UNITED STATES  
DEPARTMENT OF THE INTERIOR  
GEOLOGICAL SURVEY

## SUNDRY NOTICES AND REPORTS ON WELLS

Apache

125

All distances must be from the outer boundaries of the Section

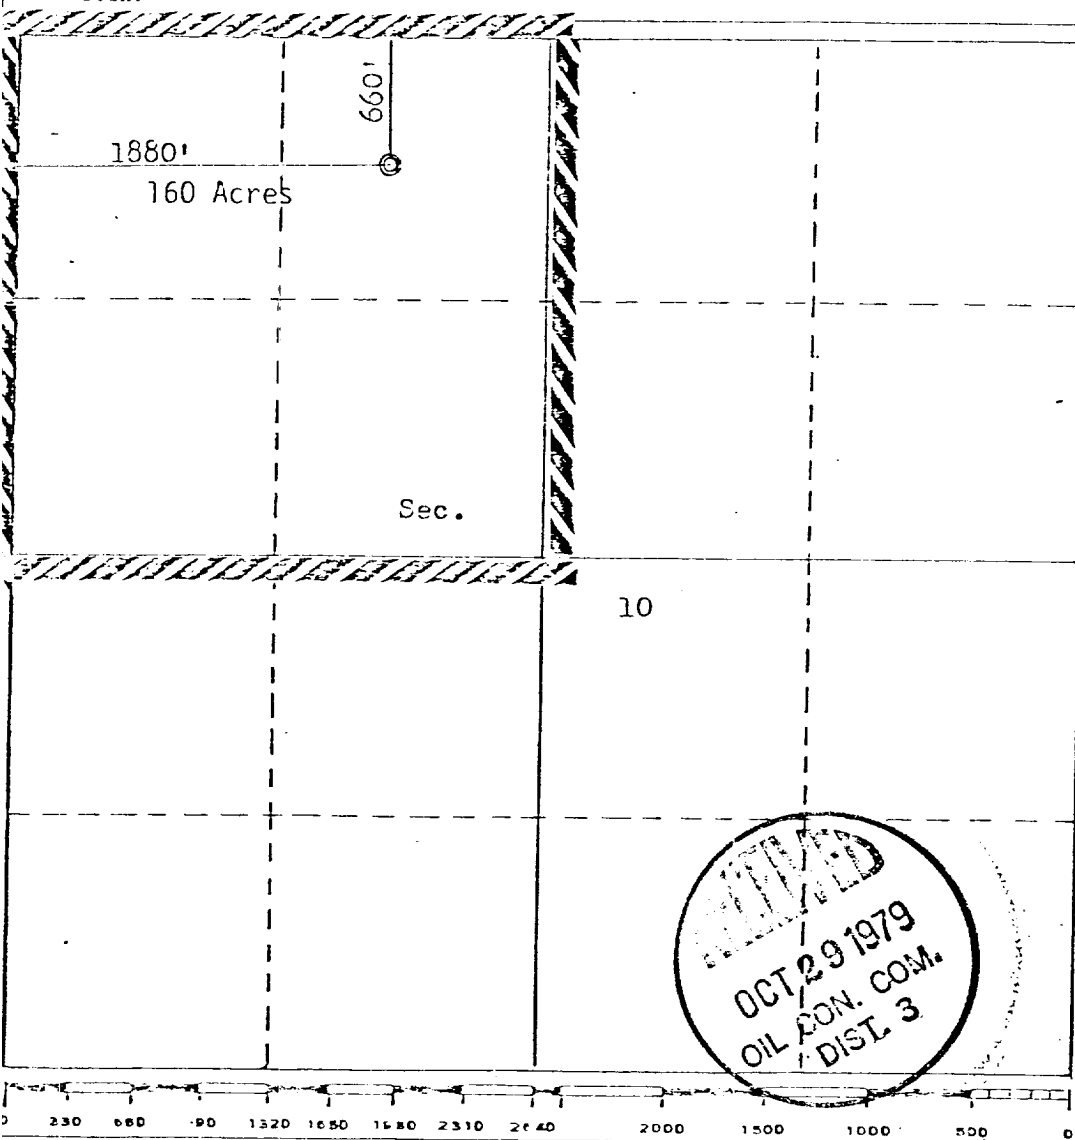
Permission is requested to move the location of the Apache #125 Gallup Dakota oil well, from 1980' FWL, 1080' FNL Section 10, to 660' FNL, 1980' FWL, Section 10.

This is required to maintain consistent spacing with the wells in Sections 4 and 9, with the well being drilled in the NE $\frac{1}{4}$  of a quarter section.

| Actual Footage Location of Well:<br><b>660</b> feet from the <b>North</b> line and <b>1880</b> feet from the <b>West</b> line |                                             |                        |                                            |                                        |  |
